Final San Juan Basin Cumulative Overview and Comment Letters

Bureau of Land Management
New Mexico State Office
Santa Fe, New Mexico

September 1983

The comment letters pertain to the November 1982 Draft San Juan Basin Cumulative Overview, proposed New Mexico Generating Station and possible New Town, and the San Juan River Regional Coal Environmental Impact Statements.

Figure E-3. TRADEOFFS

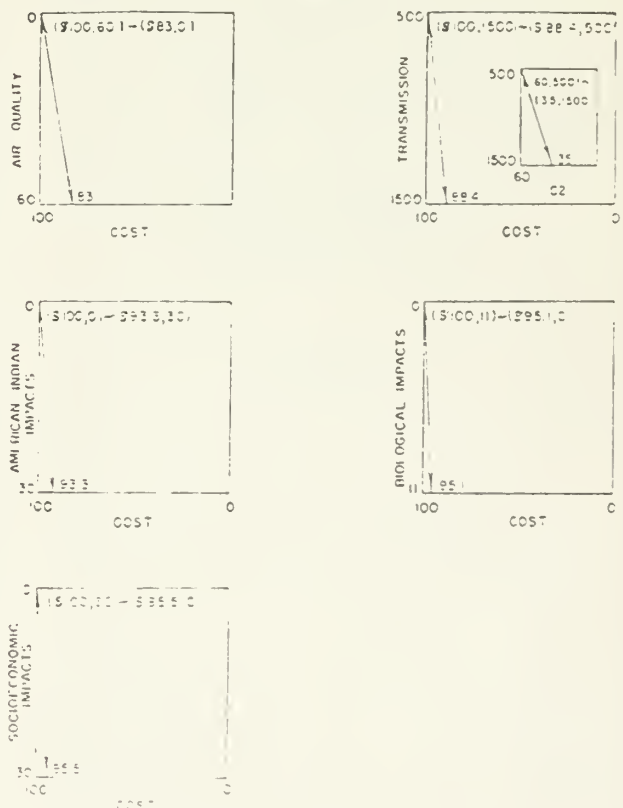
Again, relative weights for different economic, environmental, and social factors are not given, so the numbers in Table 3-1 are useless to an individual decisionmaker. SRIC has briefly reviewed the actual tradeoffs used to convert environmental and socioeconomic impacts into dollars (WCL, "NHGS Site Selection Report," December 1980, Appendix E, p. E-51, Figure E-3 (attached)). This review shows that, buried deep in an appendix to an unpublished report backing up a technical report to the OEIS, the BLM gave more than twice as much weight to cost as to all other impacts combined. Looking just at air quality (cost is shown in millions of dollars; impacts in micrograms of SO₂ per cubic centimeter), Figure E-3 shows that reducing air pollution to zero would only be worth \$17 million. This valuation utterly flies in the face of reality; at the 1600MW Four Corners 4-5 project, for example, the owners (including PNM) are currently spending over \$300 million just to reduce sulfur emissions about two-thirds. Figure E-3 says that it would not be worth it to spend \$17 million more even if that \$17 million could completely eliminate sulfur emissions. In fact, since no other air pollutant is included in the BLM's tradeoff analysis, SO₂ acts as a proxy for all air pollutants. So Figure E-3 says that it's not worth spending more than \$17 million even to eliminate sulfur, nitrogen, and particulate emissions together. The BLM may think \$17 million is a fair tradeoff for all the air pollutants from a 2000 MW coal plant, but Congress obviously did not when it passed the Clean Air Act. The BLM ignores the societal value of clean air by using the tradeoffs in Figure E-3.
